Commonwealth Edison
72 West Adams Street, Chicago, Illinois
Address Reply to: Post Office Box 767
Chicago, Illinois 60690 - 0767

June 20, 1989

Subject: Dresden Station Units 2 and 3
Revised Fire Protection Procedure for
Opposite Unit Safe Shutdown Equipment
Out-of-Service
NRC Docket Nos. 50-237 and 50-249

3/4.2.2 SAFE SHUTDOWN EQUIPMENT AFFECTING UNIT 3 FIRE SAFE SHUTDOWN
LIMITING CONDITION FOR OPERATION

FIGURE 3.2.2-1
 INOPERABLE OPPOSITE UNIT SAFE SHUTDOWN EQUIPMENT FLOW DIAGRAM

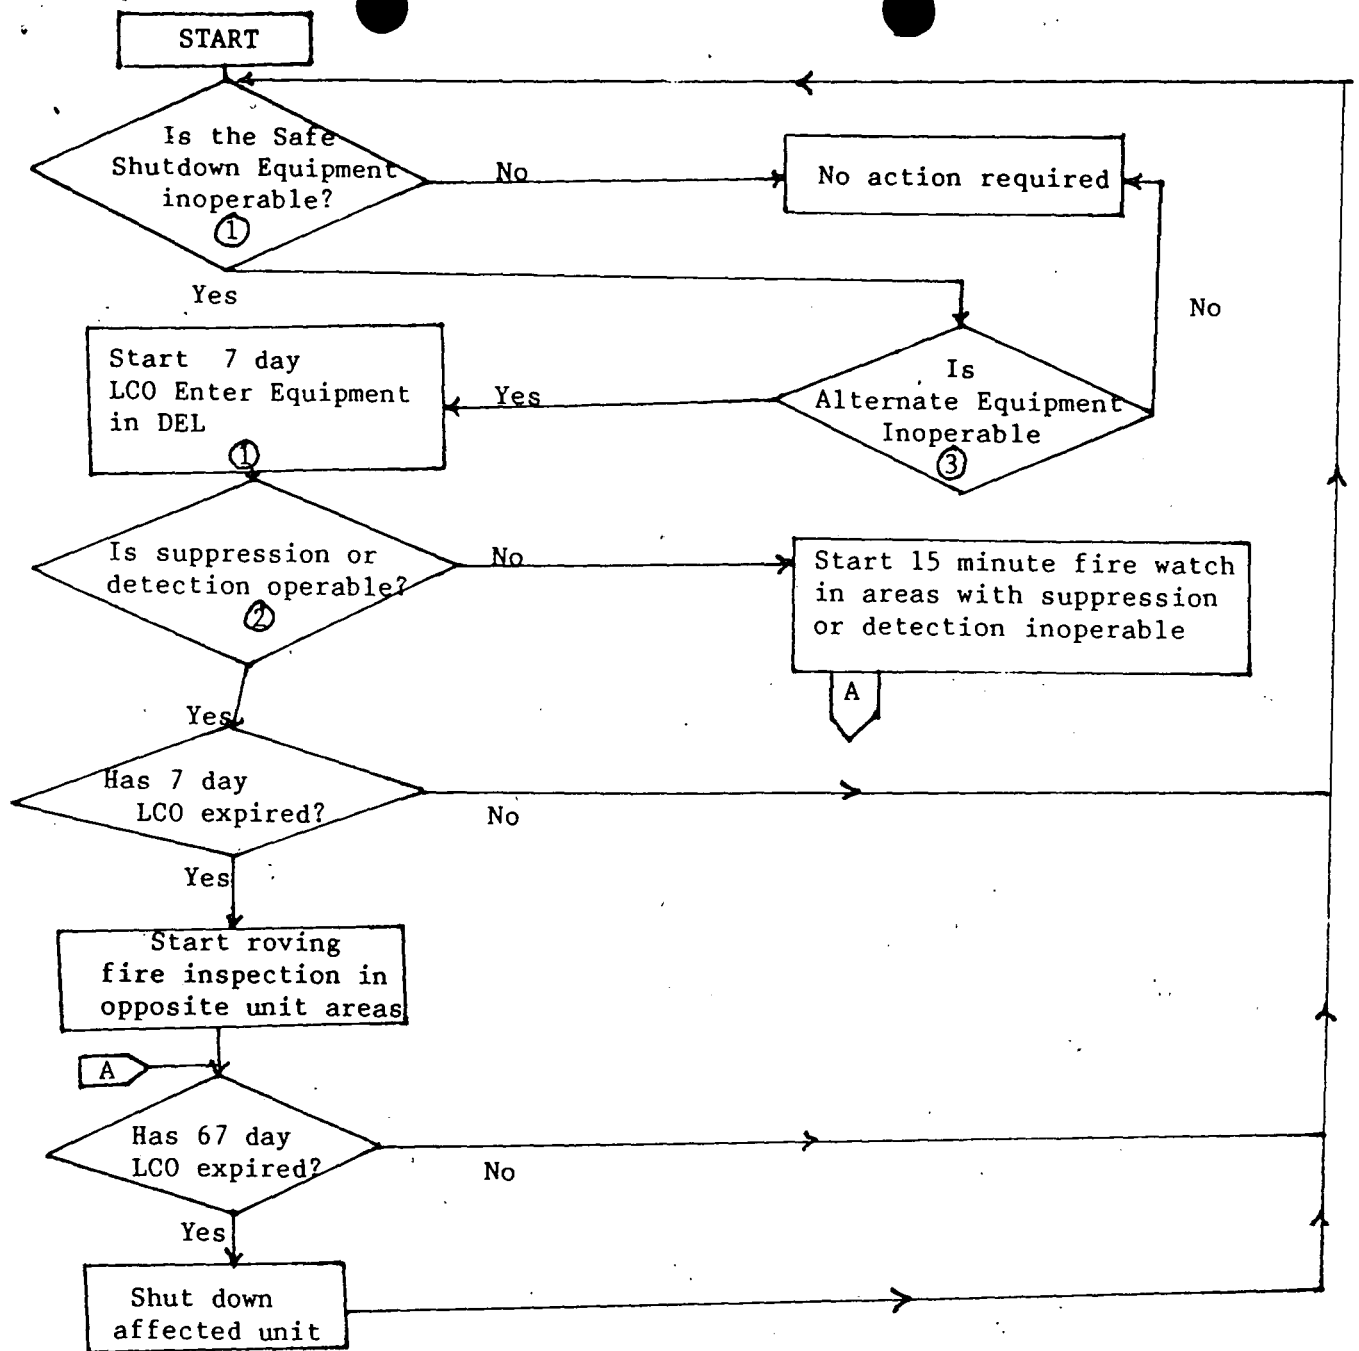
- a. The equipment listed in Table 3.2.2-1a shall remain inoperable for no longer than seven days unless the alternate equipment listed in Table 3.2.2-1b is operable [Note A]. During this period operable detection instrumentation or automatic suppression systems are required in the Unit 2 fire areas that utilize the inoperable equipment in order to obtain post fire safe shutdown conditions [Note B].

- b. If the equipment in Table 3.2.2-1a and its alternate equipment in Table 3.2.2-1b is inoperable and detection or automatic suppression systems in the Unit 2 fire areas that utilize the inoperable equipment in order to obtain post fire safe shutdown conditions are inoperable:

- 2) A temporary video camera(s) will be installed in the high and low pressure heater bays as directed by Fire Marshal, within 1 hour. Monitors will be located in non-high radiation areas and will be monitored by the dedicated continuous 15 minute fire watch.

- 2) A dedicated once per hour fire inspection [Note C] shall be established within one hour in the above non-high radiation areas,
 - 3) A temporary video camera(s) will be installed in the high and low pressure heater bays as directed by Fire Marshal, within 1 hour. Monitors will be located in non-high radiation areas and will be monitored by the dedicated once per hour fire inspection.

FIGURE 3.2.1-1
 INOPERABLE OPPOSITE UNIT SAFE SHUTDOWN EQUIPMENT FLOW DIAGRAM

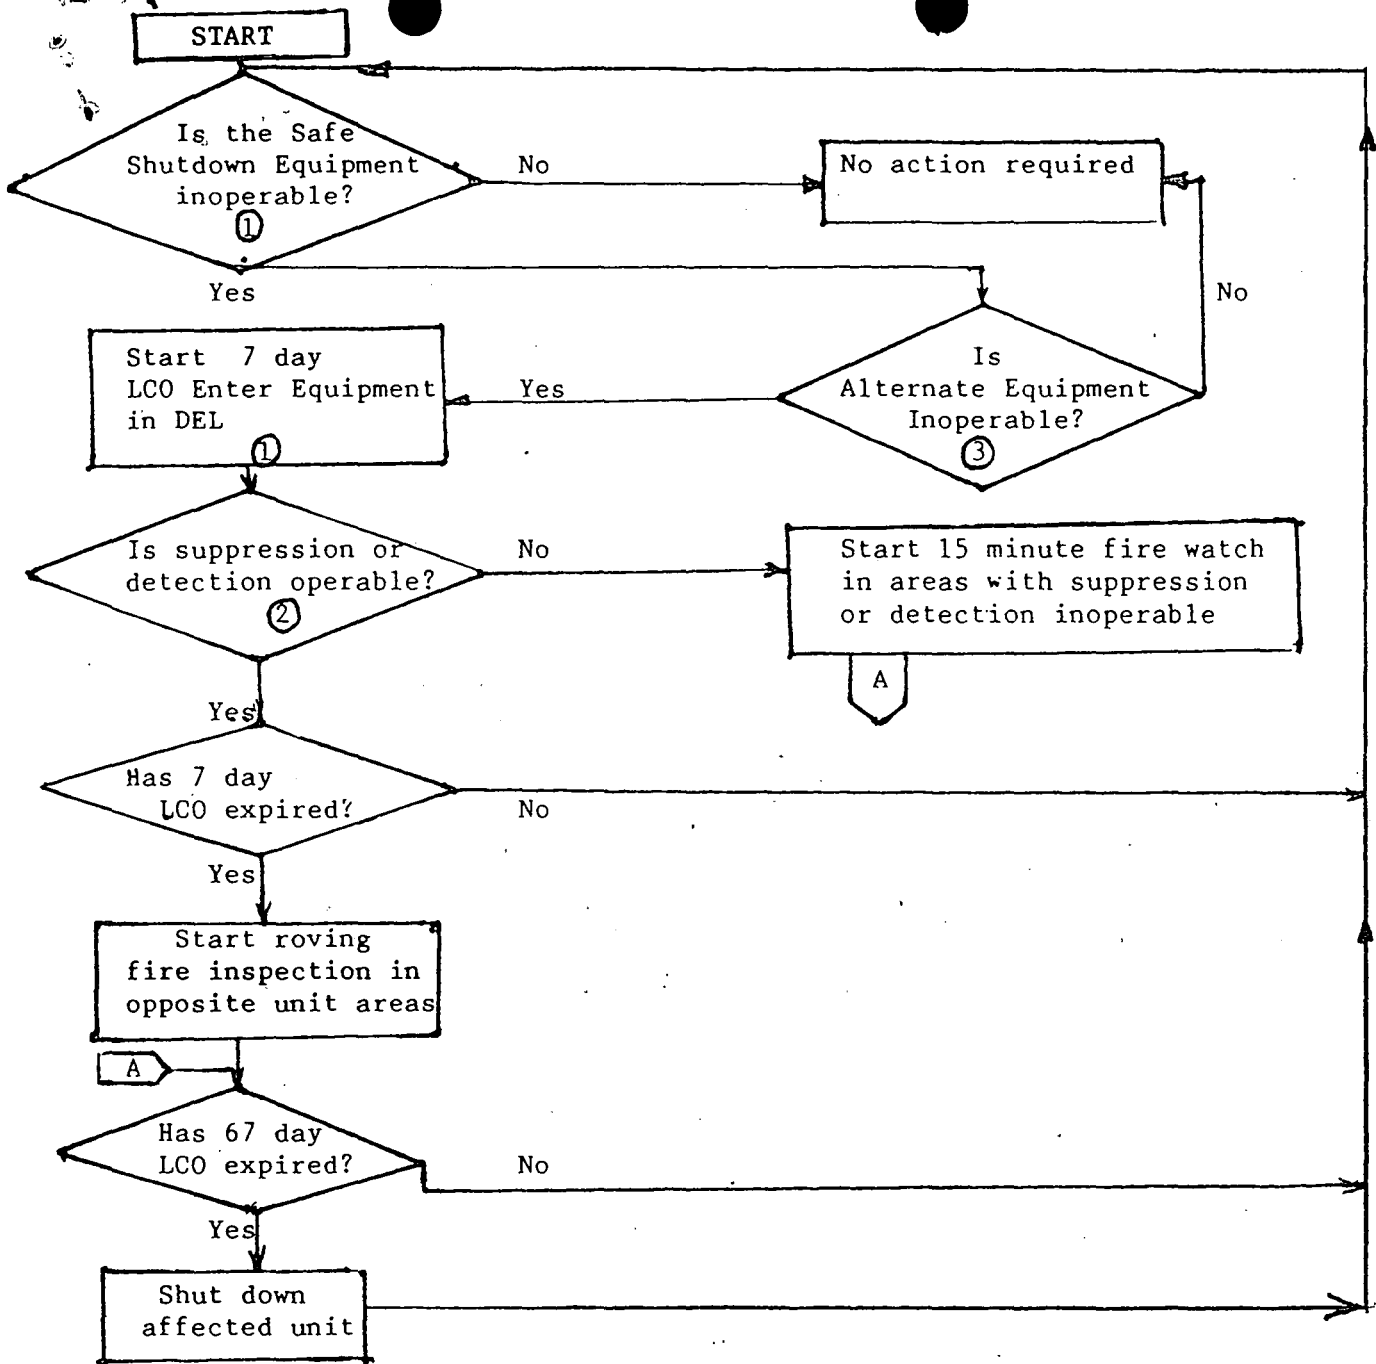
- a. The equipment listed in Table 3.2.1-1a shall remain inoperable for no longer than seven days unless the alternate equipment listed in Table 3.2.1-1b is operable [Note A]. During this period operable detection instrumentation or automatic suppression systems are required in the Unit 2 fire areas that utilize the inoperable equipment in order to obtain post fire safe shutdown conditions [Note B].

- b. If the equipment in Table 3.2.1-1a and its alternate equipment in Table 3.2.1-1b is inoperable and detection or automatic suppression systems in the Unit 2 fire areas that utilize the inoperable equipment in order to obtain post fire safe shutdown conditions are inoperable:

- 2) A temporary video camera(s) will be installed in the high and low pressure heater bays as directed by Fire Marshal, within 1 hour. Monitors will be located in non-high radiation areas and will be monitored by the dedicated continuous 15 minute fire watch.

- 2) A dedicated once per hour fire inspection [Note C] shall be established within one hour in the above non-high radiation areas,
 - 3) A temporary video camera(s) will be installed in the high and low pressure heater bays as directed by Fire Marshal, within 1 hour. Monitors will be located in non-high radiation areas and will be monitored by the dedicated once per hour fire inspection.
